From: Ryan Nehls <rnehls@reaeng.com>
Sent: Friday, June 24, 2022 11:41 AM
To: Koepke, Cynthia L - DNR
Cc: Bill Buckingham; Brian Flad
Subject: Shorewood Commons BRRTS #02-13-560698
Attachments: HydroGraph.pdf; Well Screen & Water Levels.pdf; Site Map.pdf

GROUNDWATER ELEVATION MAP (5/20/22)
 PHASE II INVESTIGATION
 SHOREWOOD COMMONS
 3330 UNIVERSITY AVENUE
 SHOREWOOD, WI 53705

FIGURE 2.1

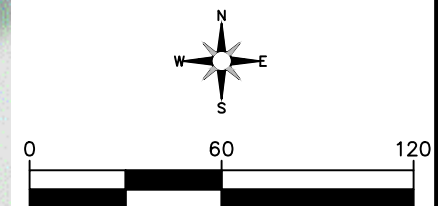
2. Some cross-sections and a chart showing the well screen depths can help show if the wells might be in different units with different hydraulic conductivities or with the screen submerged etc.
See attached Well Screen & Water Levels. The wells are ordered in what is assumed upgradient to downgradient. We're below the screens on MW-1R and MW-4.
